STATE OF CONNECTICUT
CONNECTICUT SITING COUNCIL

APPLICATION OF CELLCO PARTNERSHIP)	
d/b/a VERIZON WIRELESS FOR A)	
CERTIFICATE OF ENVIRONMENTAL)	DOCKET NO. 413
COMPATIBILITY AND PUBLIC NEED FOR THE)	
CONSTRUCTION, MAINTENANCE, AND)	
OPERATION OF A WIRELESS)	April 14, 2011
TELECOMMUNICATIONS FACILITY LOCATED AT)	
723 LEETES ISLAND ROAD IN THE TOWN)	
OF BRANFORD, CONNECTICUT)

NEW CINGULAR WIRELESS PCS, LLC ("AT&T")
RESPONSES TO TOWN OF BRANFORD INTERROGATORIES

ATTACHMENT 5

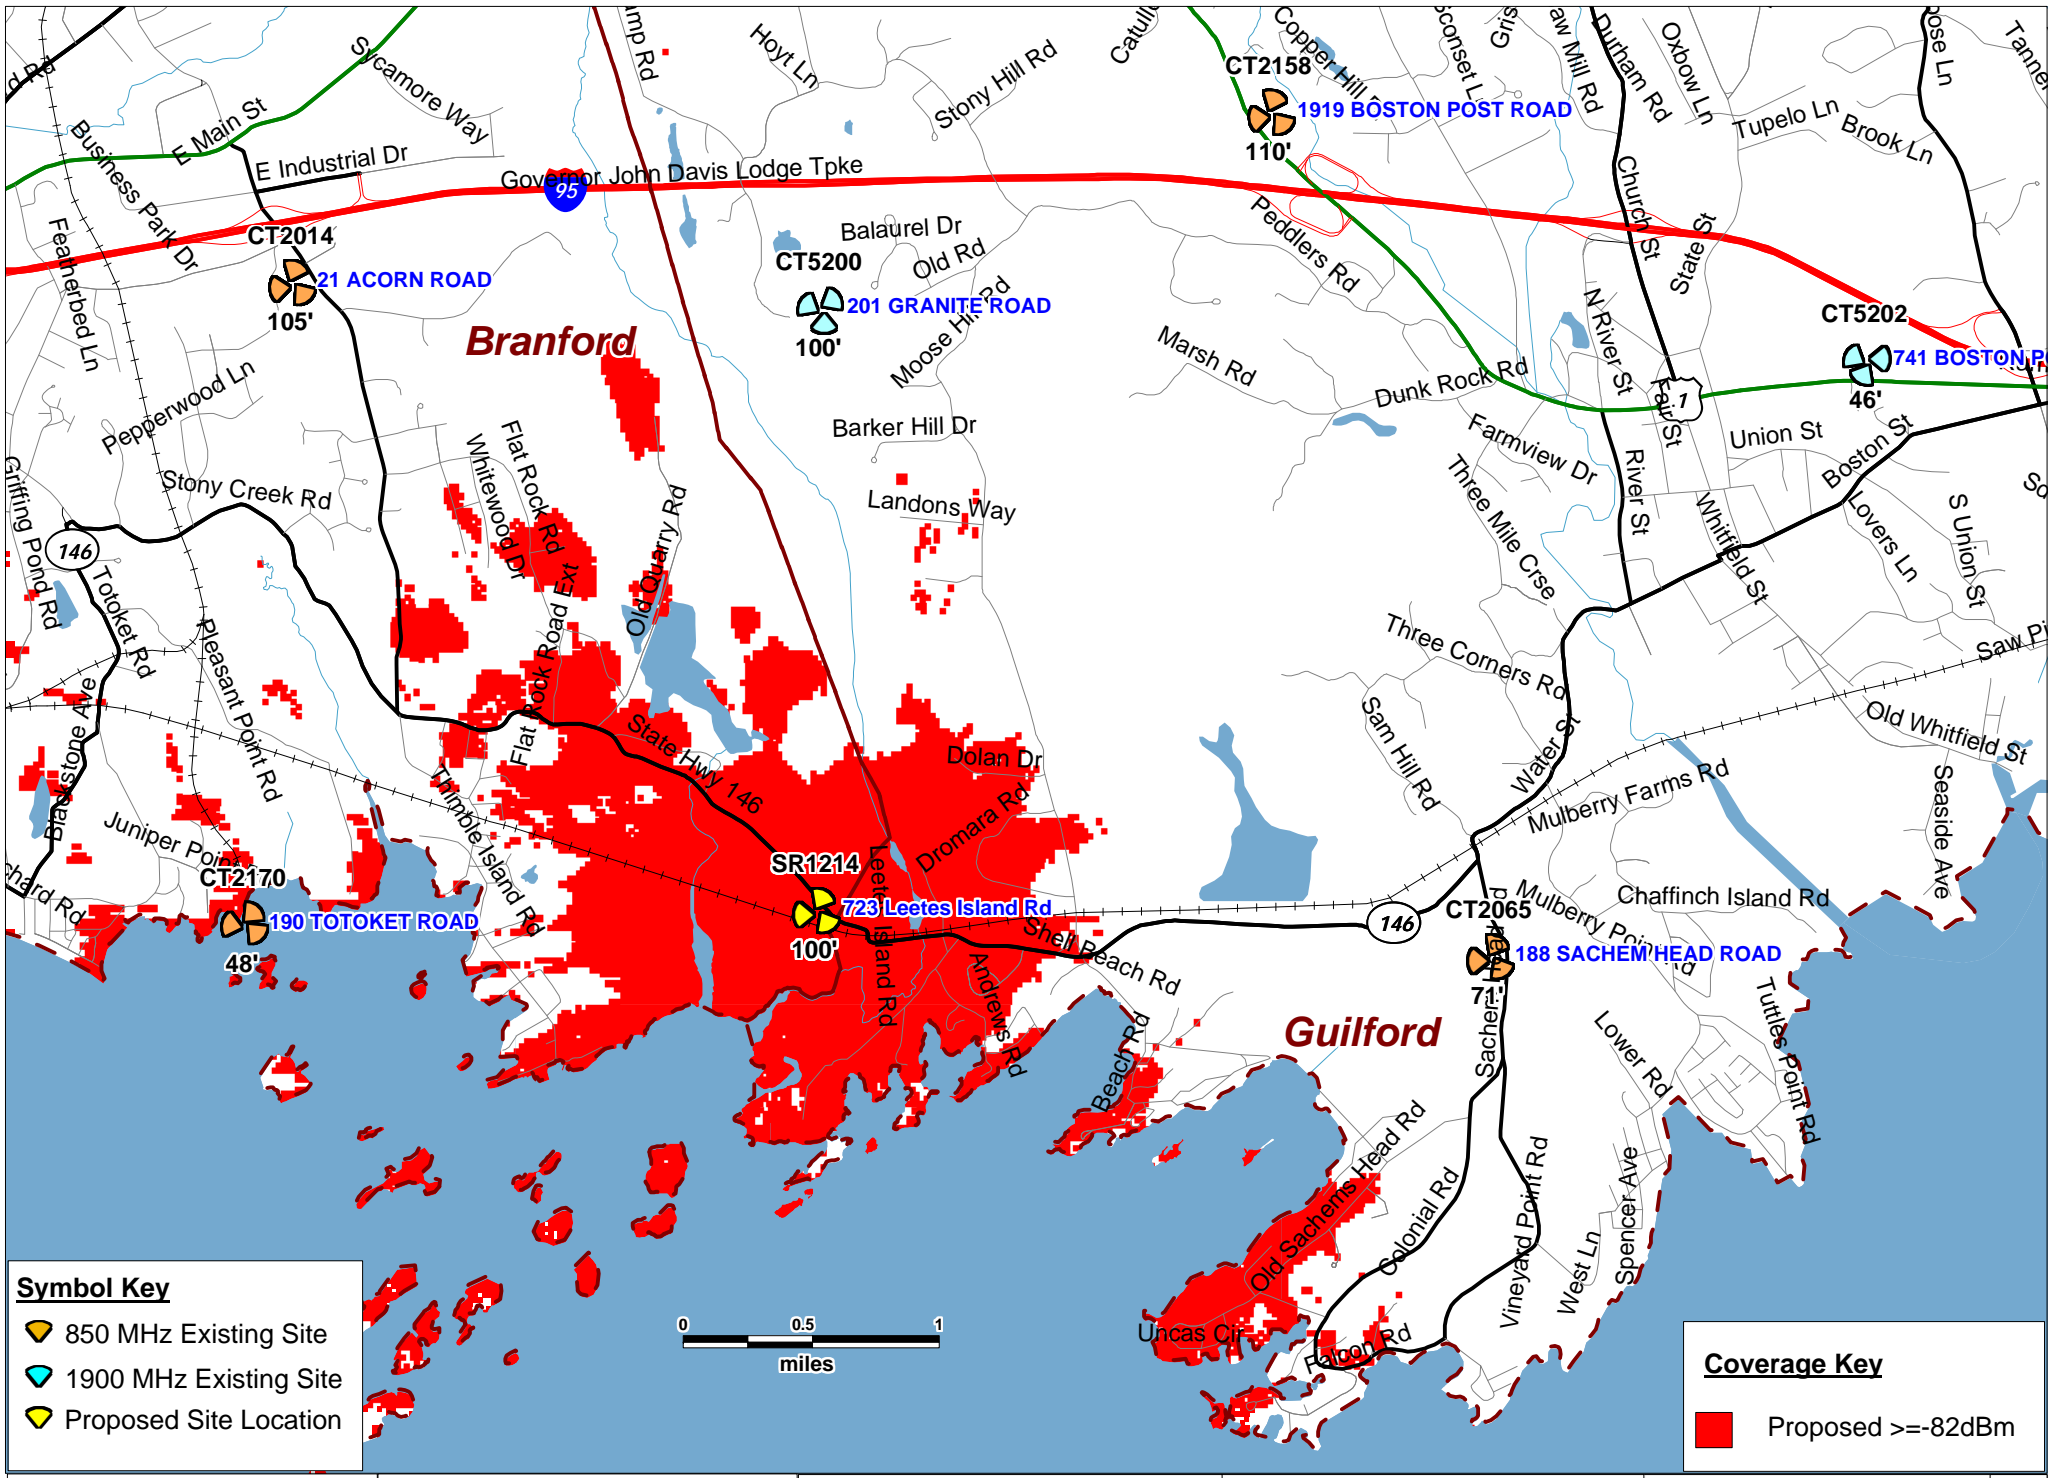
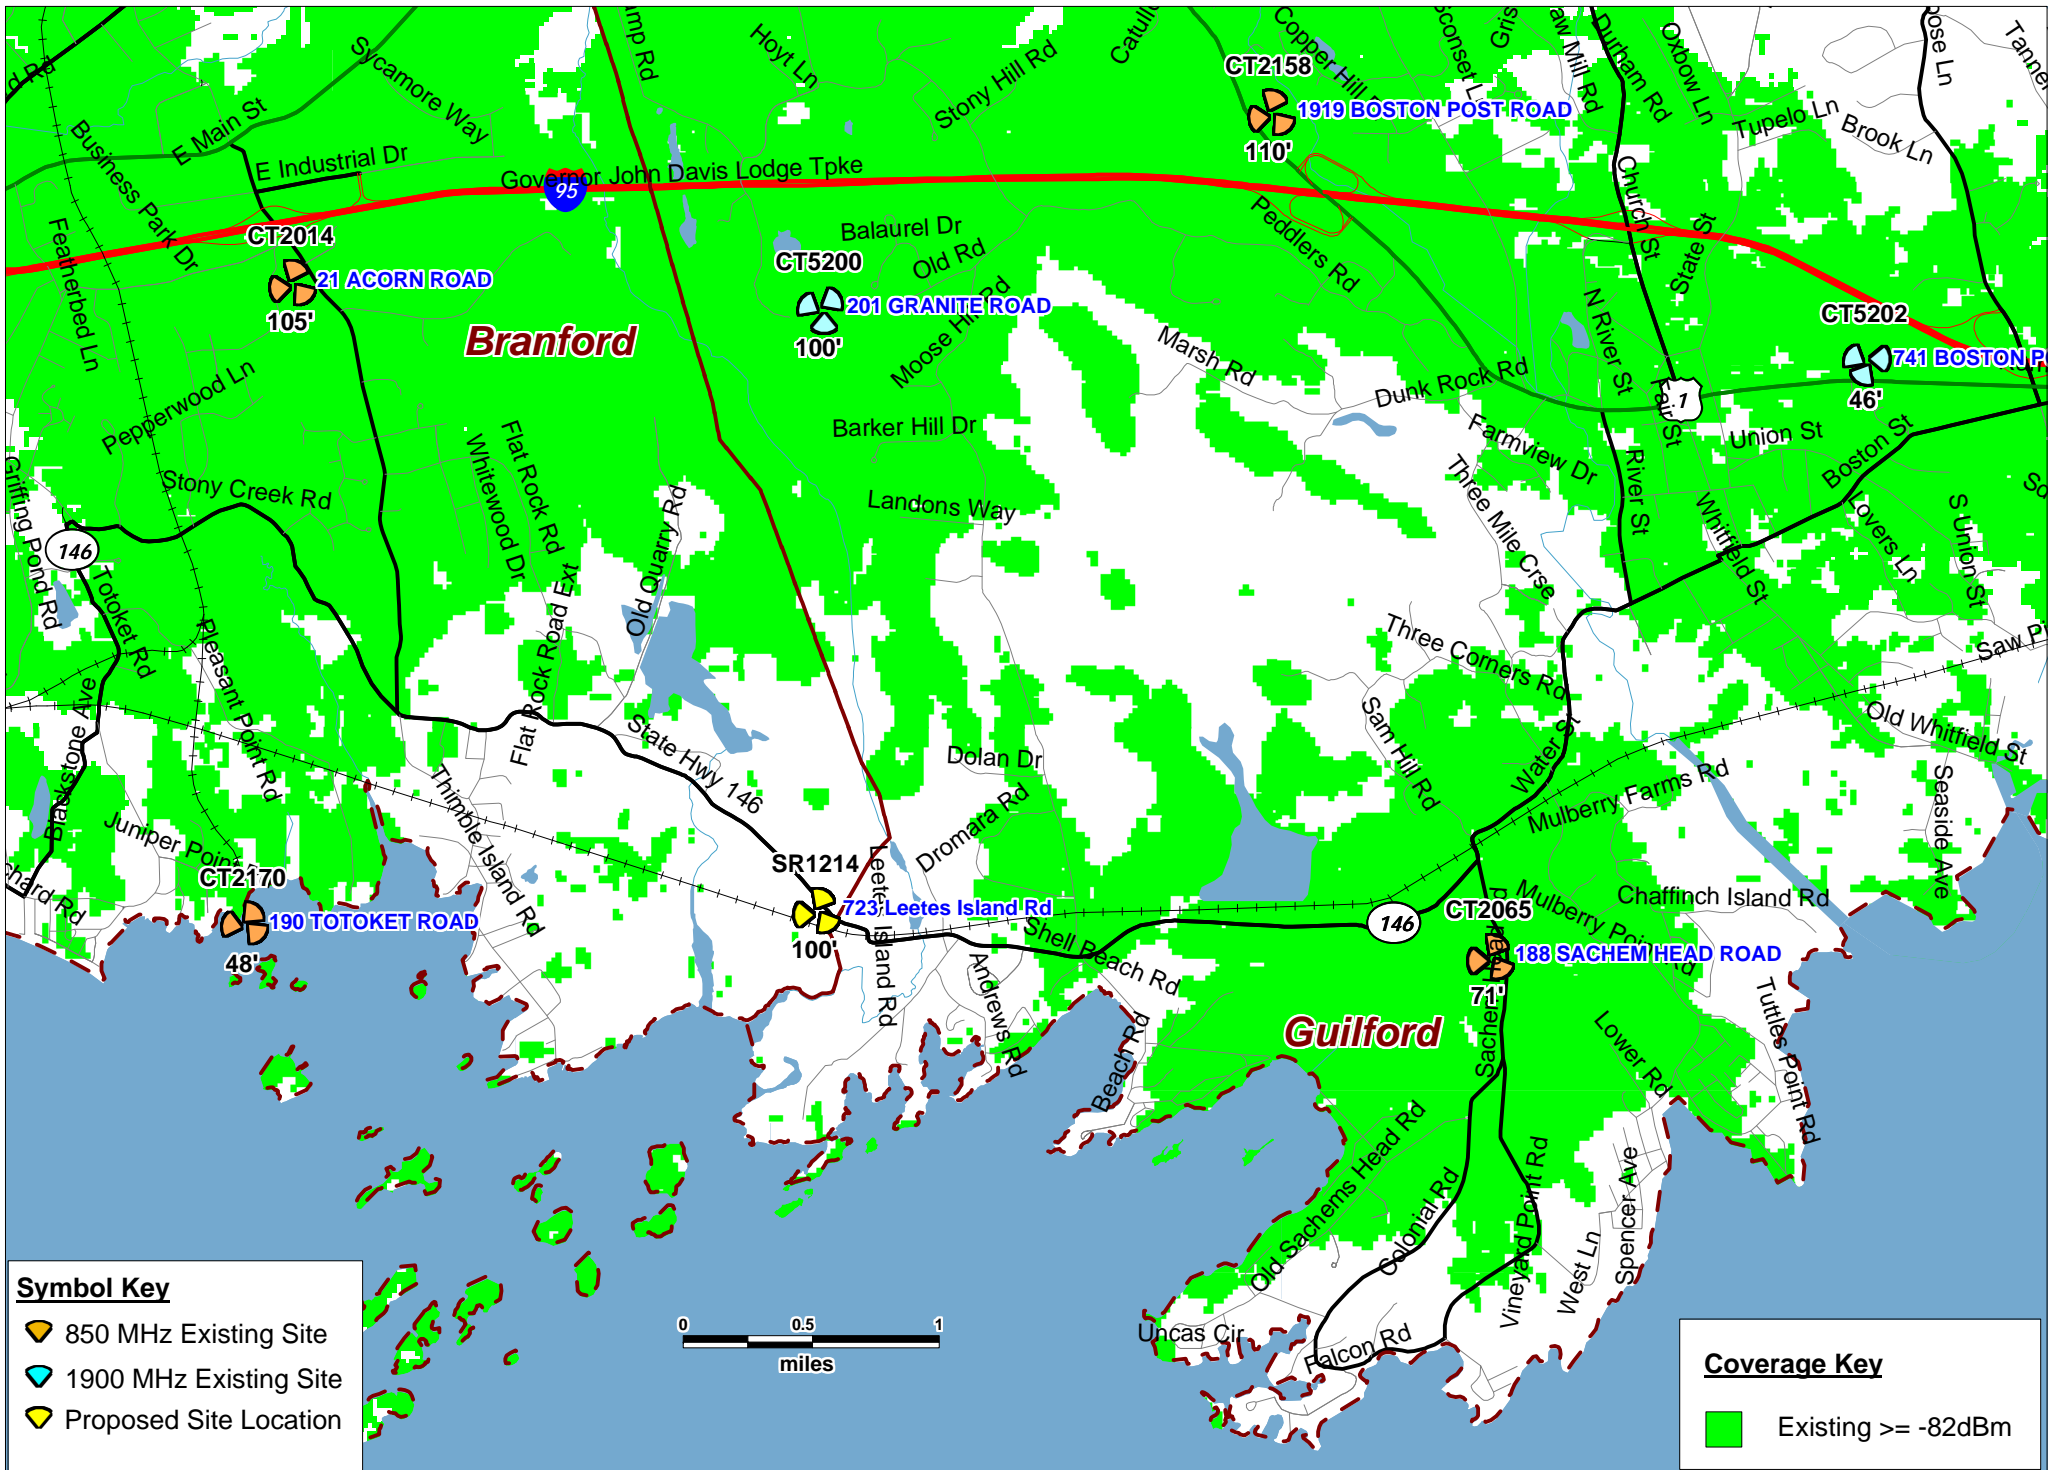
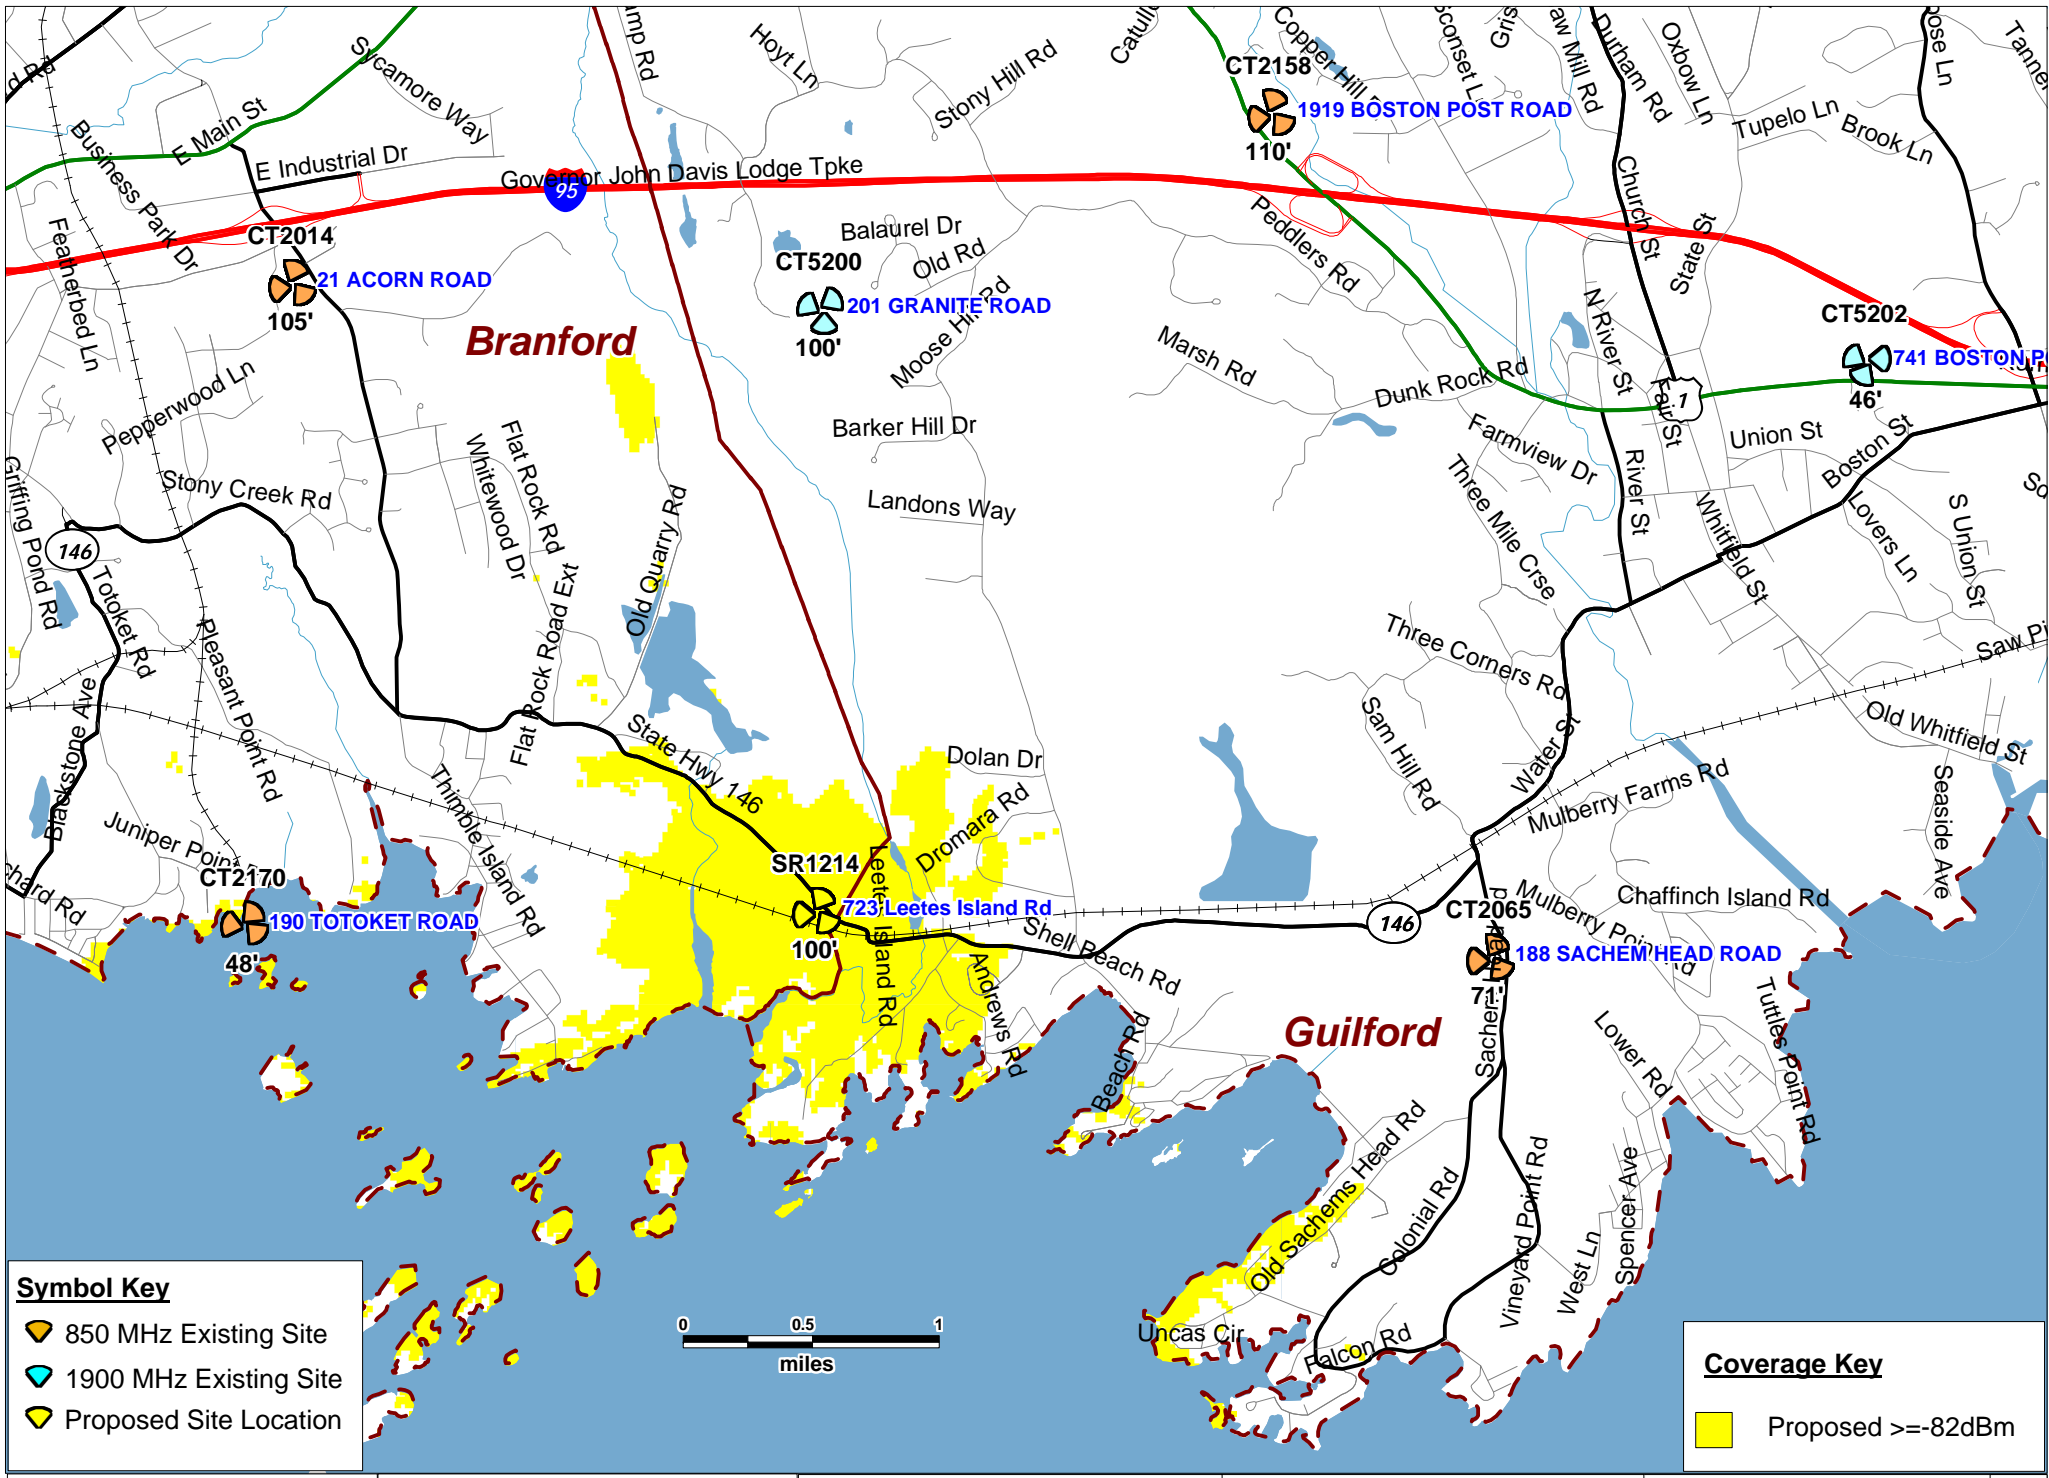
Q38. Can you provide coverage propagation maps and isolated propagation maps for the proposed facility on clear plastic overlays using a scale that matches that of the Application?

A38. The requested plots are included in Attachment 5.
